Review comments on the 2010 Reclamation MAA Documents

RT Brown, ICF International

August 13, 2010

Figure 1. Monthly Historical Flow (cfs) and EC ( $\mu\text{S}/\text{cm}$ ) at Maze and at Vernalis for 1976-1991.

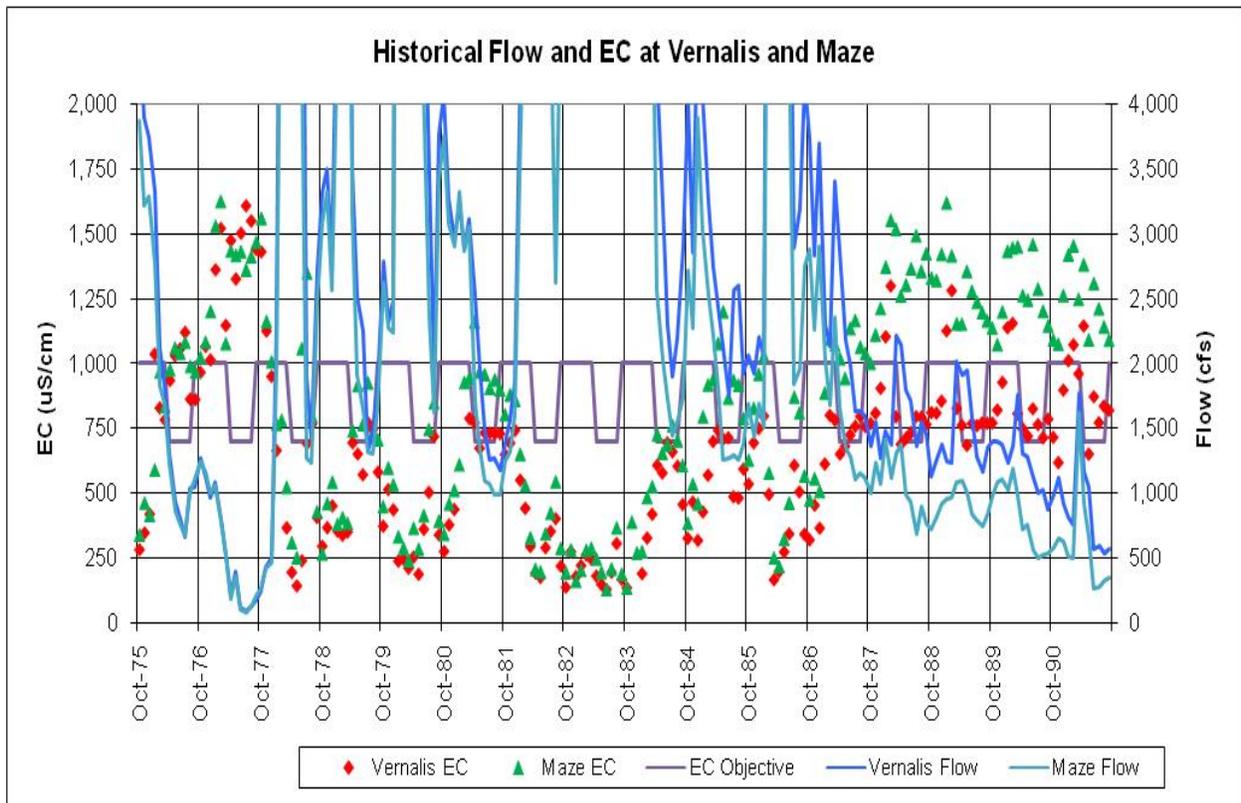
Figure 1 shows the monthly Maze and Vernalis flows and EC data for WY 1976-1991, which is the standard period of DSM2 simulations often used to describe the range of Delta EC conditions in planning studies (e.g., South Delta Improvements Program and the OCAP BA alternatives). The flow at Vernalis (dark blue line) is always higher than the flow at Maze (light blue line) because the Stanislaus River enters the San Joaquin River between these two stations. The Vernalis EC (red diamonds) is always lower than the EC at Maze (green triangles) because the Stanislaus River EC is about 100 uS/cm and always provides a dilution effect at Vernalis. During 1976 and 1977 there was low SJR flow at Maze (less than 1,000 cfs) and almost no increase at Vernalis. But during the 1988-1991 period when SJR flow at Maze was less than 1,000 cfs, there was (beginning in March) about 250-500 cfs added by New Melones Reservoir releases to dilute the SJR EC to the required EC objective of about 750 uS/cm (500 mg/l TDS required in D-1422). The 1995 WQCP Vernalis EC objectives (purple line) are shown for reference in Figure 1, although this was not the Vernalis EC objective during this 1976-1991 period. During months with higher Maze flows (more than 2,000 cfs), the Maze EC was already less than the Vernalis EC objectives and there was no need for dilution flows to meet the EC objectives.

Figure 2. Estimated Stanislaus River Flow needed to meet Vernalis EC objectives for 1976-1991.

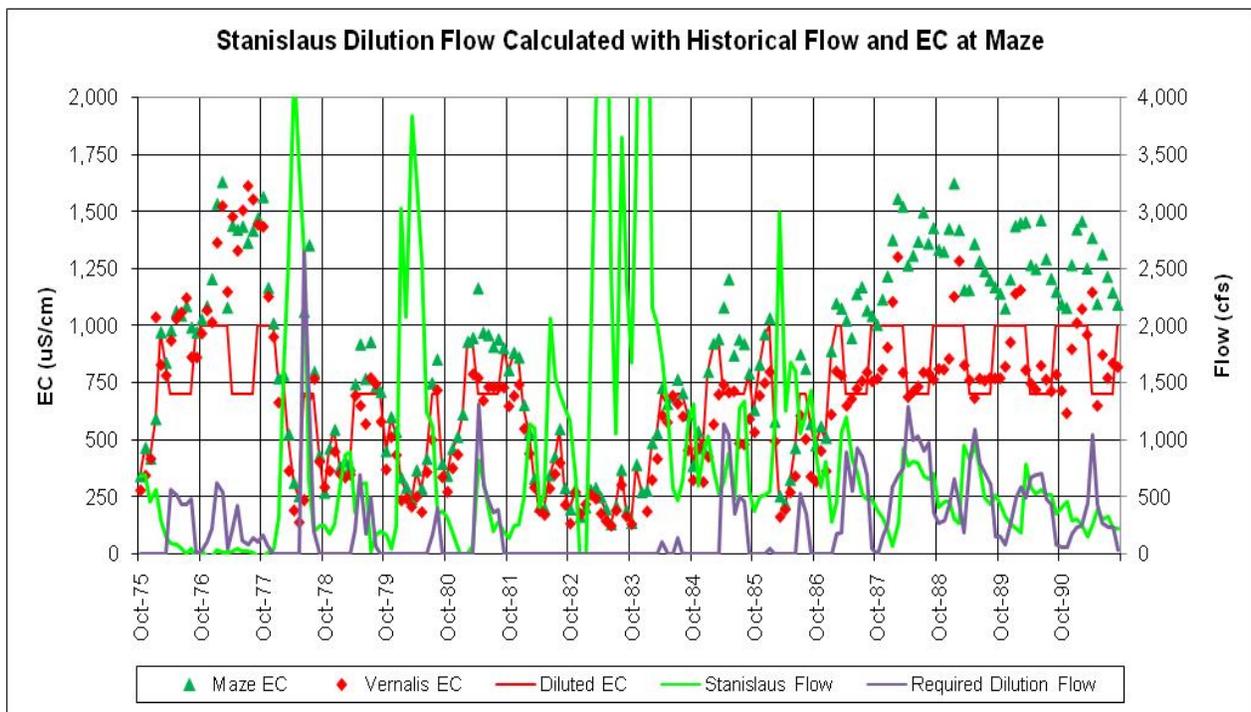
Figure 2 shows the estimated Stanislaus River dilution flow needed to meet the Vernalis EC objectives for the historical Maze flow (cfs) and Maze EC (uS/cm) for water years 1976-1991. When the Maze EC is less than the Vernalis EC objective, there is no dilution flow needed. When the Maze EC is higher than the Vernalis EC objective, the necessary dilution flow is calculated as:

$$\text{Needed Stanislaus Flow (cfs)} = \text{Maze Flow} \times (\text{Maze EC} - \text{EC Objective}) / (\text{EC objective} - \text{Stanislaus EC})$$

The Stanislaus EC was assumed to be 100 uS/cm. More dilution flow is needed when the Maze flow is high, but only when the Maze EC is higher than the EC objective. The calculated dilution flow (purple line) was often 500-1,000 cfs in the low flow months when the EC objective is 700 uS/cm. The historical Stanislaus River flows (green line) were generally higher than the required dilutions flows. During wet years (when New Melones Reservoir is filled), the Stanislaus river flows were often higher than necessary for salt dilution. The assimilative capacity credit should be calculated only for the dilution flow required to meet the Vernalis EC objectives:

Figure 3. Calculated Assimilative Capacity TMDL Credit (tons) for Stanislaus Releases Required to meet the Vernalis EC Objectives.

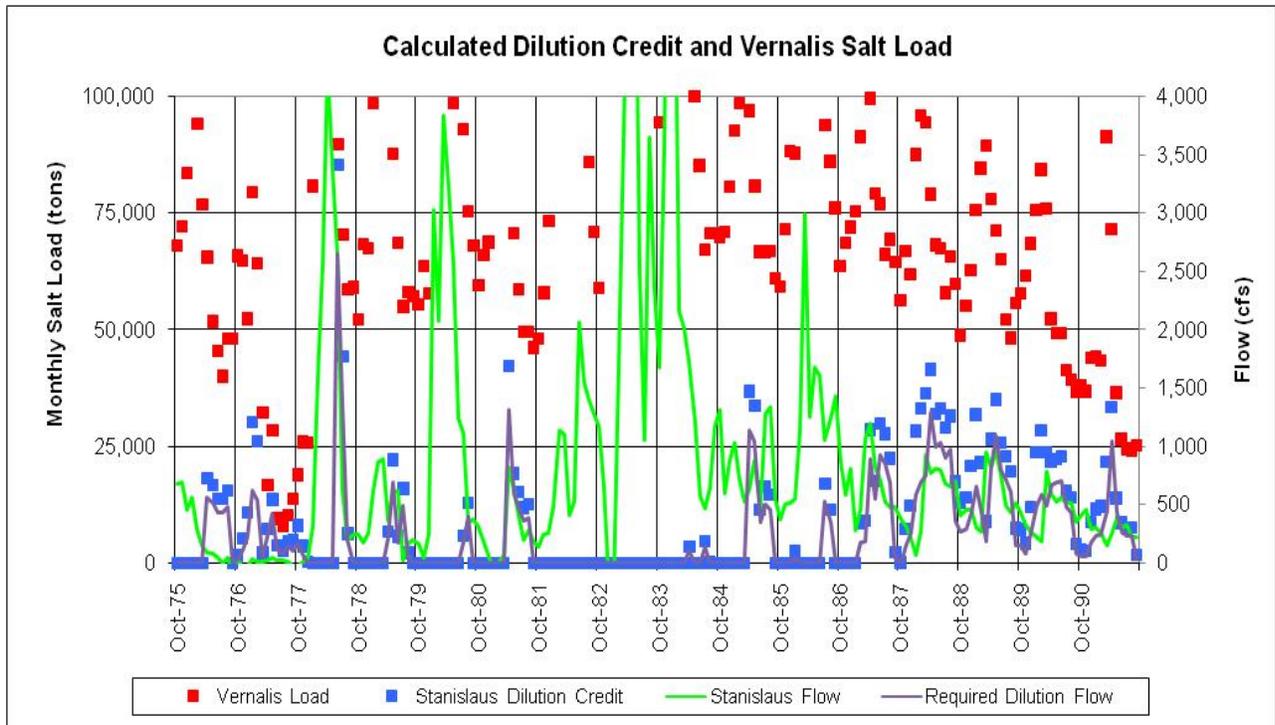
Figure 3 shows the calculated monthly Vernalis salt load (tons) and the corresponding Stanislaus release credit (tons) for the historical flow and salinity measured at Maze for 1976-1991. The monthly Vernalis salt loads were about 50,000 to 100,000 tons during the summer irrigation season in most years. The monthly salt loads were less than 50,000 tons in 1977 and in 1990 and 1991 because of low deliveries and low seepage sources. The calculated assimilative capacity credits were about 20,000 to 30,000 tons in months when calculated Stanislaus TMDL releases were 500 to 1,000 cfs. These Stanislaus TMDL assimilative capacity credits are a great benefit for implementing the TMDL to match the existing salt loads in the San Joaquin River with sufficient flows to meet the Vernalis EC objectives. But calculating an assimilative capacity credit for every month of releases from New Melones Reservoir is not appropriate.

Figure 4. Historical Flow (cfs) and EC (uS/cm) and Calculated Salt Load (tons) at Vernalis for 1976-1991.

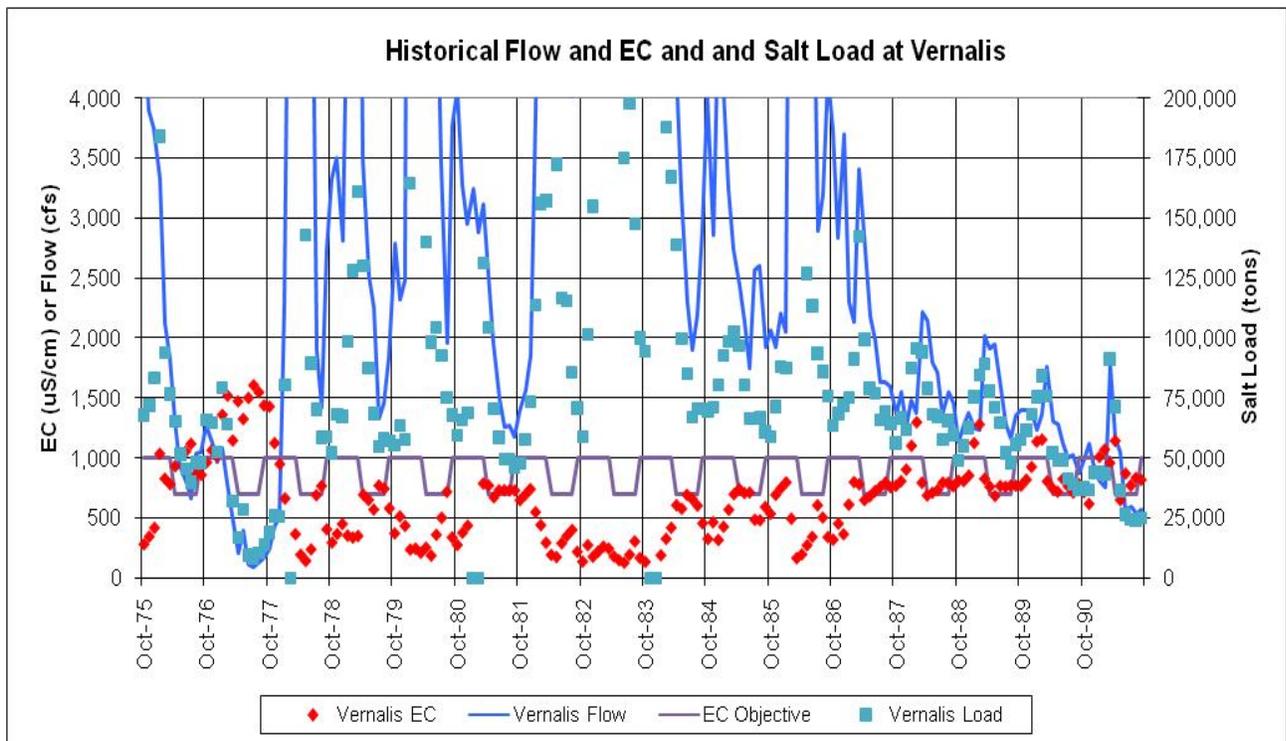
Figure 4 shows the historical Vernalis flow, EC and calculated salt load for WY 1976-1991. This figure illustrates the difficulty of TMDL management without always identifying the source of the loads. Only high concentrations of salt (or other contaminants) cause an impact to beneficial uses. Loads that may be high because of high flows do not need to be managed or regulated. This figure also summarizes the important role of flow management for reducing the salinity (or contaminant concentration) to the water quality objectives. Reducing the salt load from other beneficial activities, such as irrigation for agriculture or wastewater from urban areas, will not likely prove successful. When the SJR salinity is relatively high, the most practical management action will likely be flow management.

Figure 4 illustrates the TMDL implementation options and the purpose of the MAA. The overall goal of the TMDL is to meet the Vernalis EC objectives. The purpose of the monthly accounting of individual flows and salt loads that contribute to the Vernalis salt load is to identify excess salt loads that can be reduced or shifted in time. However, it is difficult to accurately account for the many sources of salt within the lower SJR basin. This is the motivation for the SJR WARMF watershed model that is being used to guide the CV-SALTS program. The MAA represents Reclamation's share of the flow and salt accounting within the lower SJR. A TMDL implementation report should be prepared by RWQCB staff to clarify these accounting and management issues for Reclamation and all stakeholders.
